Index 102-680 Haul Road Crossing

ORIGINATION

COMMENTS AND RESPONSES

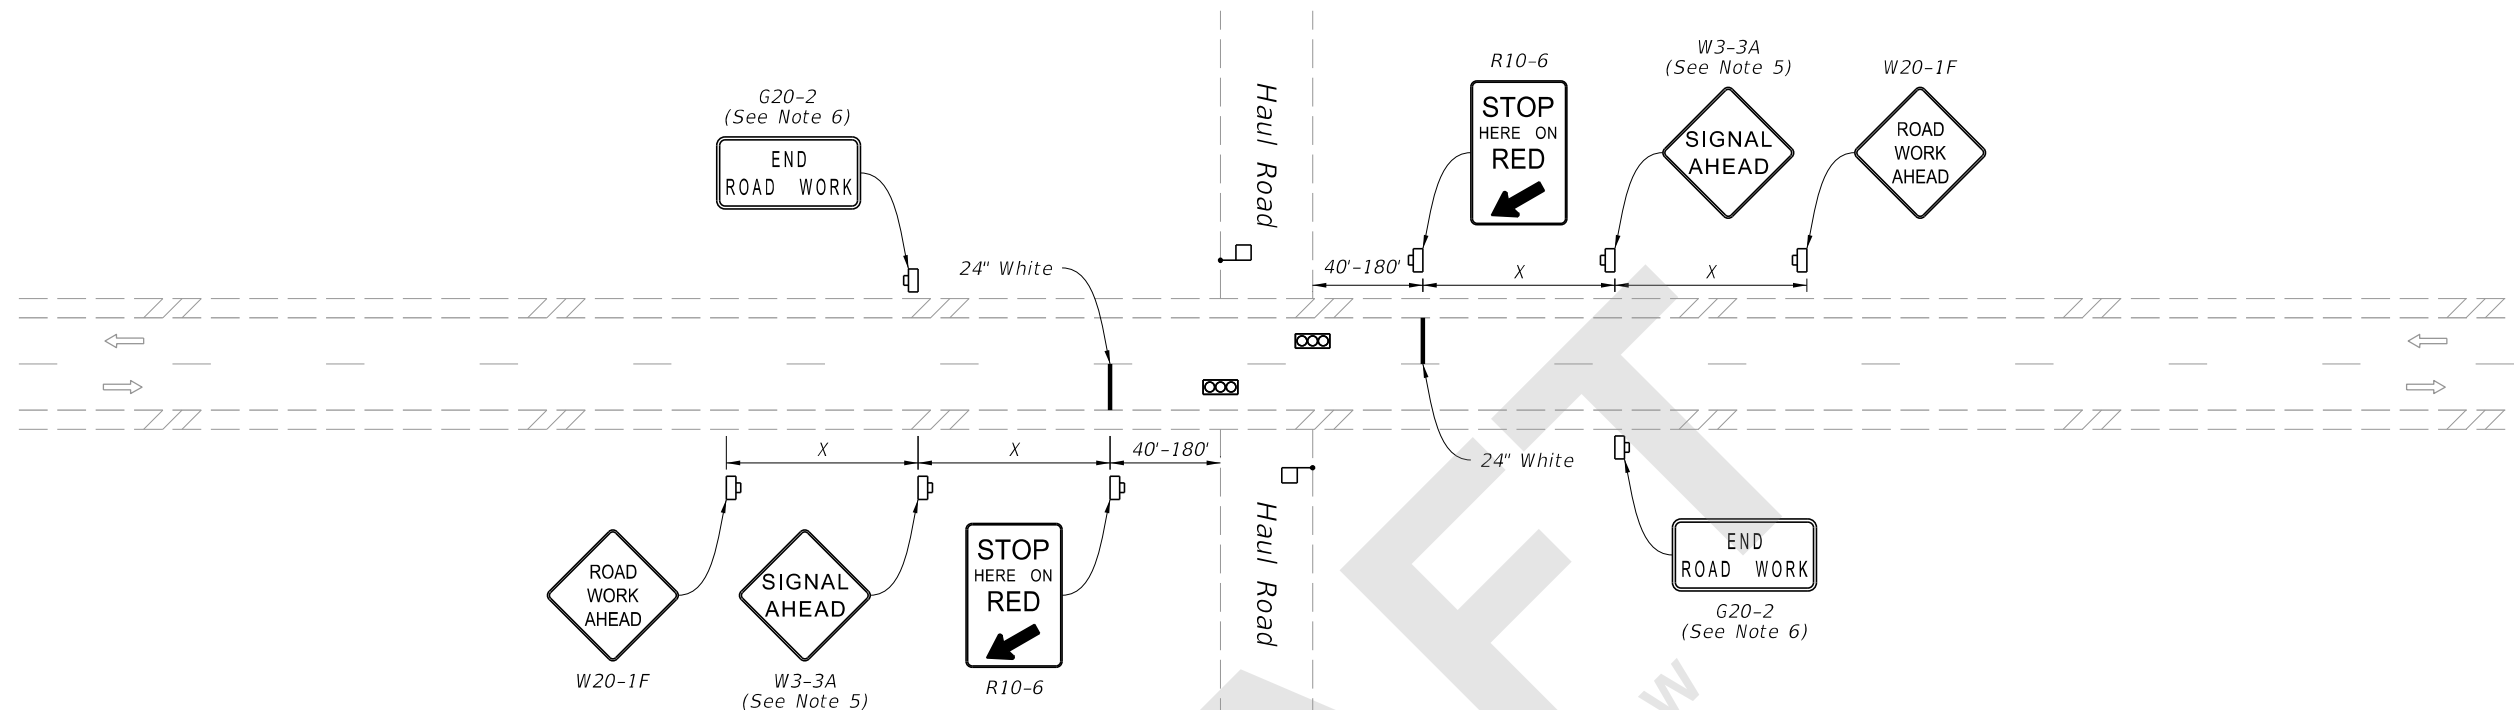
1. Sheet 1: How was the 80-150 ft. distance determined?

2. Sheet 1: Signal Ahead sign callout note incorrect. Correct to "See Note 5"

RESPONSE: *The original intent was to match the signal to stop-bar dimension used within Index 102-606; however, after additional consideration the detail will be modified to more closely match the MUTCD.*

Change Made: *The location of the stop-bar from the signal has been changed to 40'-180' to match the MUTCD.*

RESPONSE: *Agreed*

Change Made: *Call-out corrected.*
